Ref: 17165-Waitara-Access Report R3-201217

WAITARA PUBLIC SCHOOL

**DISABILITY DISCRIMINATION ACT (DDA) COMPLIANCE REPORT
FINAL DA STAGE REVIEW**

DECEMBER 2017

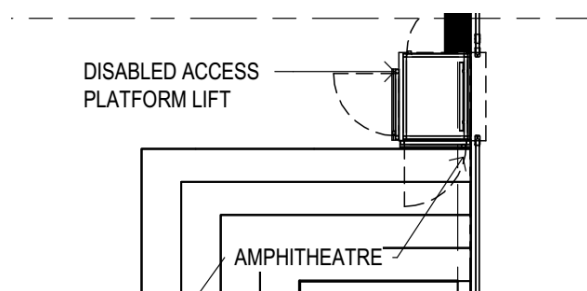
The stage is required to be accessible and it is proposed to be provided with a platform lift.

A platform lift is also proposed for the external amphitheatre.

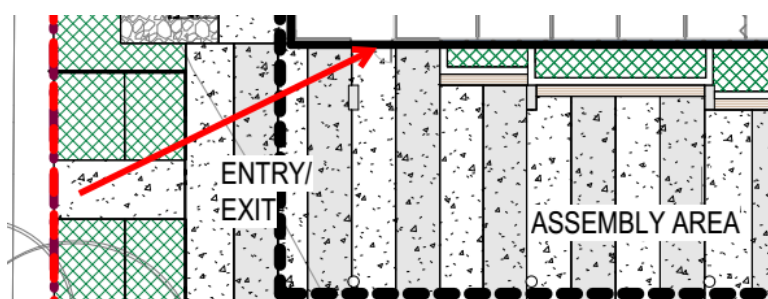
The proposed new main pedestrian entry into the school from Myra Street is required to be accessible and to provide an accessible path of travel to the existing and proposed buildings on site. Note that the new pathways on site should be on grade or have a maximum gradient of 1:40 if a ramp or walkway is not provided.

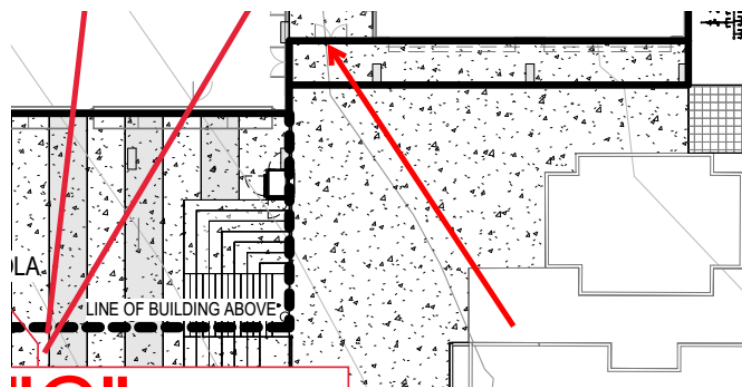
An accessible path of travel is required to be provided to the building from the other accessible buildings on site. A stairs must not form the only pedestrian path from the rest of the school site, a ramp or walkway is also required.

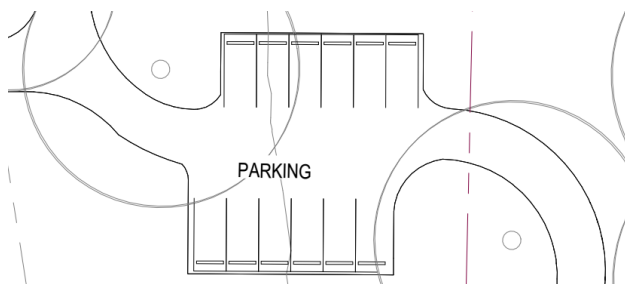
Confirm if the site is proposed to be provided with an accessible carspace. If it is disabled access is required to be provided from the accessible carspace to the proposed building. Note the addition of new carspaces on site will trigger the requirement for an accessible carspace to be provided.

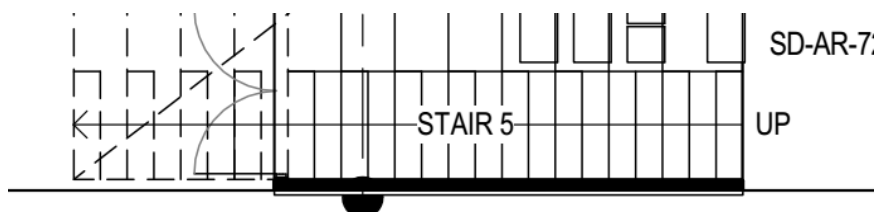
The lack of a second handrail to the amphitheatre stair will be noted as a non compliance on the Section 109R Crown Works Certificate.

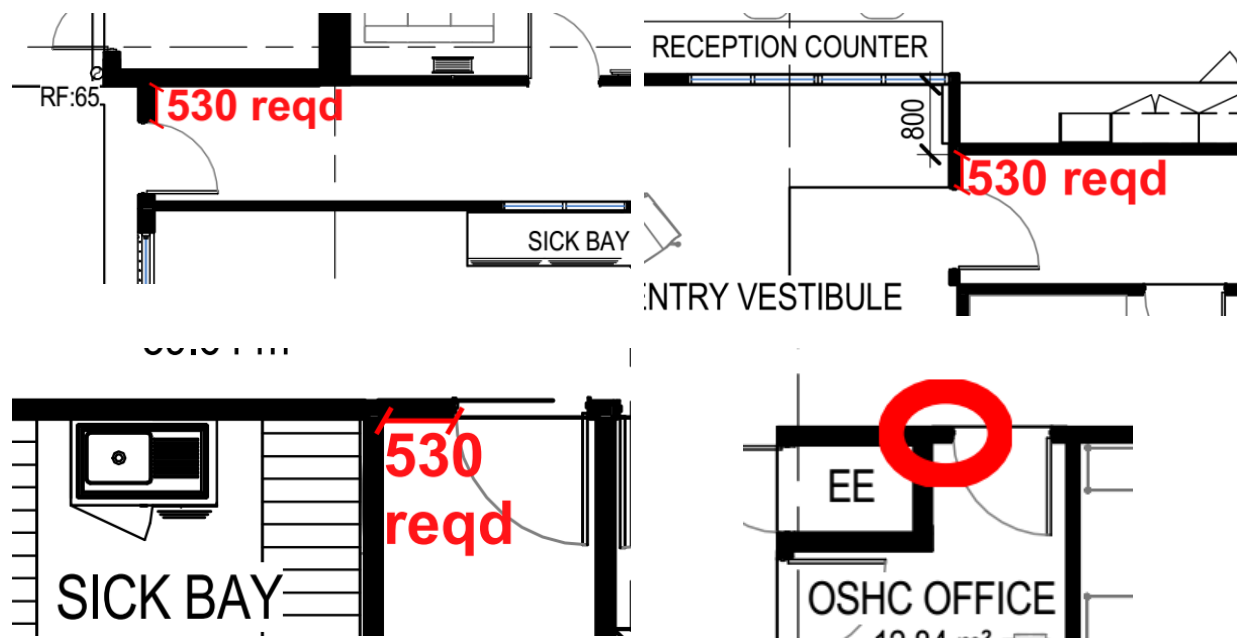
The circulation spaces to the following doorways is required to be modified during design development to comply with the circulation space requirements of AS1428.1 2009.

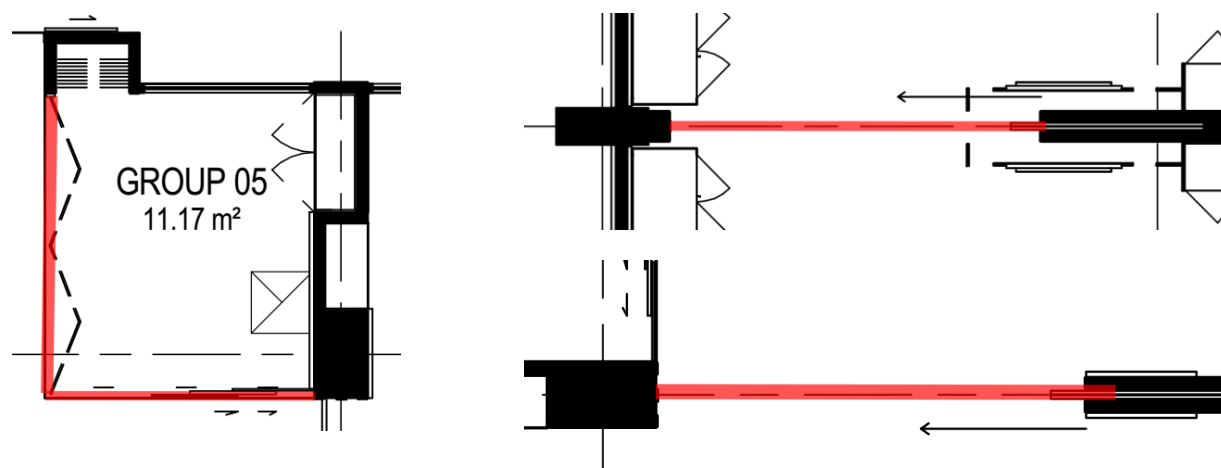
The compliance of the following sliding doorways to the circulation space requirements of AS1428.1 2009 is required to be confirmed during design development.

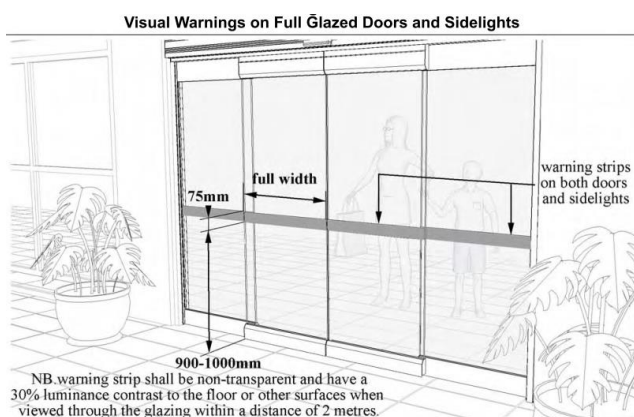
The lack of compliant wheelchair seating spaces to the amphitheatre will be noted as a non compliance on the Section 109R Crown Works Certificate.
